Access Compliance Report

Public Rights-of-Way

Intersection ID: 18375	Main Street: MONTCLAIR_AV	Cross Street: WESTBURY_RD	Location: SE
ADA ID: EB1B2B7E25FF	Ramp Type: BlendTrans2	Initial Pass/Fail: Fail	Overall Compliance: No
		Severity Score: 1.25

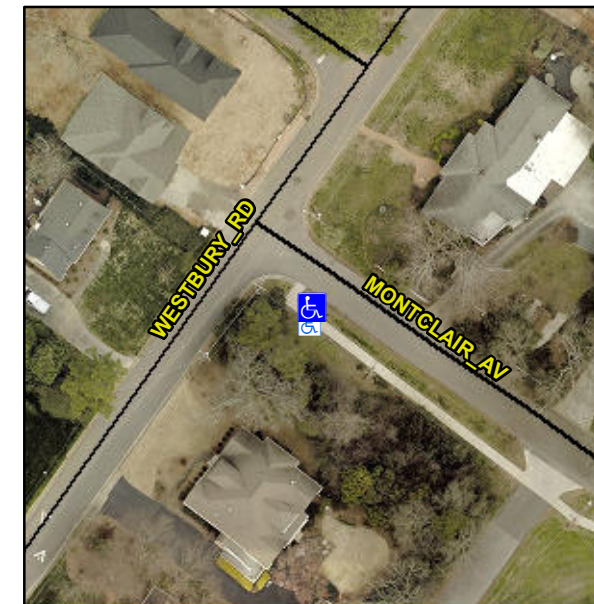
R304.5.3

Compliance	Description	Data	Compliance	Description	Data
N/A	Ramp Length (in)	125.0	Yes	BlendTrans Slope (%)	2.2
Yes	Ramp Width (in)	58.5	No	BlendTrans XSlope (%)	2.5
N/A	Flare Type LT	N/A	N/A	Flare Type RT	N/A
N/A	Flare Slope LT (%)	N/A	N/A	Flare Slope RT (%)	N/A
N/A	Flare Traversable LT?	N/A	N/A	Flare Traversable RT?	N/A
N/A	Landing Length (in)	N/A	N/A	DWS Provided?	N/A
N/A	Landing Width (in)	N/A	N/A	DWS Contrast?	N/A
N/A	Landing Slope (%)	N/A	N/A	DWS Length (in)	N/A
N/A	Landing X Slope (%)	N/A	N/A	DWS Full Width?	N/A
N/A	Landing Curb? (Y/N)	N/A	N/A	DWS Offset (in)	N/A
N/A	Shared Landing?	N/A			
N/A	Gutter Ponding?	N/A	N/A	Gutter Slope (%)	N/A
N/A	Gutter Lip Ht (in)	N/A	N/A	Gutter X Slope (%)	N/A
N/A	Painted X Walk1?	No	N/A	Painted X Walk2?	N/A
	X Walk 1 Direction	To NE		X Walk 2 Direction	N/A
	X Walk 1 Width (in)	N/A		X Walk 2 Width (in)	N/A
	X Walk 1 Slope (%)	2.1		X Walk 2 Slope (%)	N/A
	X Walk 1 X Slope (%)	3.2		X Walk 2 X Slope (%)	N/A

Remove & Replace Curb Ramp With Two New Directional Ramps or Equivalent.
